ORLANDO LUTHERAN TOWERS (OLT) II PLAT

SUMMARY

Minor Subdivision Plat

PROPOSED PLAT

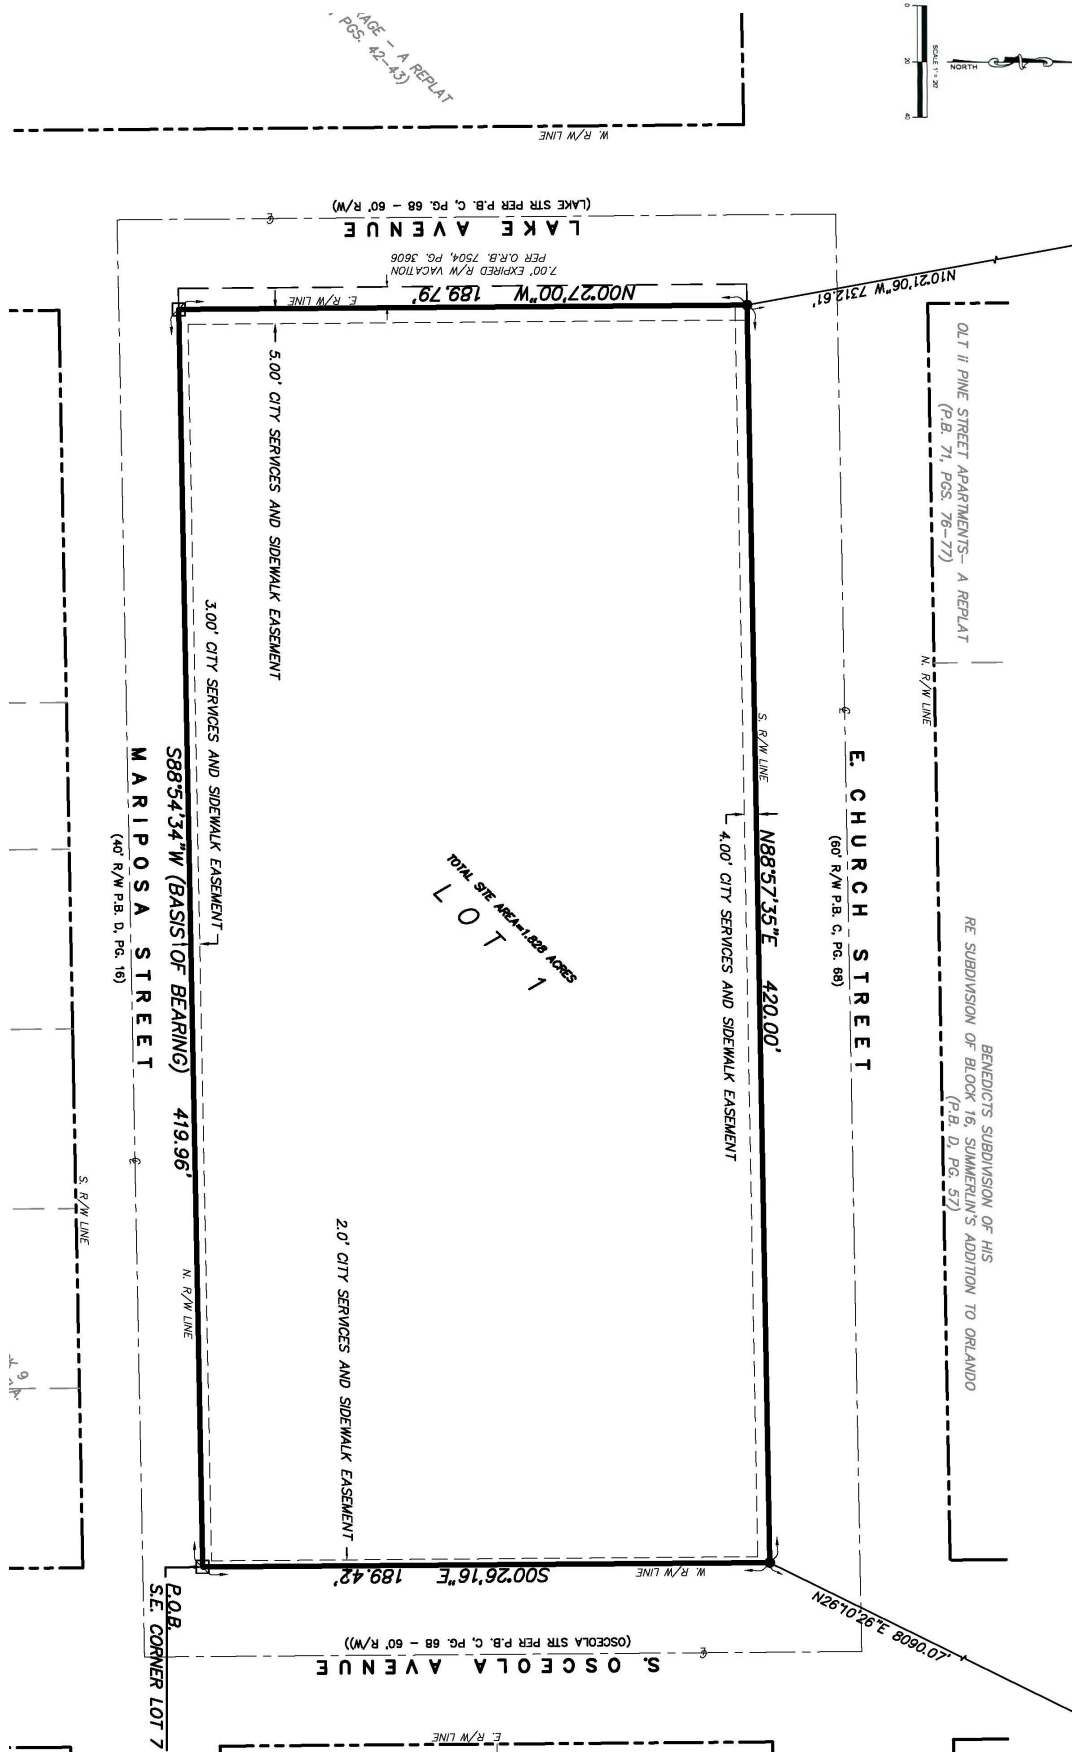
The applicant is requesting Minor Subdivision Plat approval to combine the two parcels into one. The PD ordinance requires a 5 ft. wide City services and sidewalk easement along all four roadways of the site for compliance with the South Eola Neighborhood Plan. The applicant proposes reduced easements, which staff feels meet the intent of the South Eola Neighborhood Plan but a Letter of Determination will be required to memorialize the deviation. Also, an Encroachment Agreement will be required for the projections, overhangs and such that encroachment into the easement areas.

1. General Code Compliance. Development of the proposed project shall be consistent with the conditions in this report and all codes and ordinances of the City of Orlando, the State of Florida and all applicable regulatory agencies.
2. Previous Approvals Consistency. The proposed development shall be consistent with the conditions of the approved PD ordinance and subsequent administrative approvals or modifications.
3. Encroachments. An encroachment agreement shall be required for projections that encroach into the easement areas.
4. Determination. A Planning Official Letter of Determination shall be required in conjunction with the modified proposed easements.
5. Utility Easement. Utility easement for onsite transformers shall be shown on the plat.

1. Easements. The plat submitted in PDF format via email on 12/19/13 has the required easements shown and will be approved if submitted to permitting as shown.

7. Plat- Minor. Plat Face Changes - There are a number of changes required to the face of the plat. In addition to the changes required on the plat, the following is a list of additional requirements.

- 1) Changes to the face of the plat.(A copy has already been returned to the surveyor).
 - 2) Recording Fees (Checks should be made payable Orange County Comptroller.)
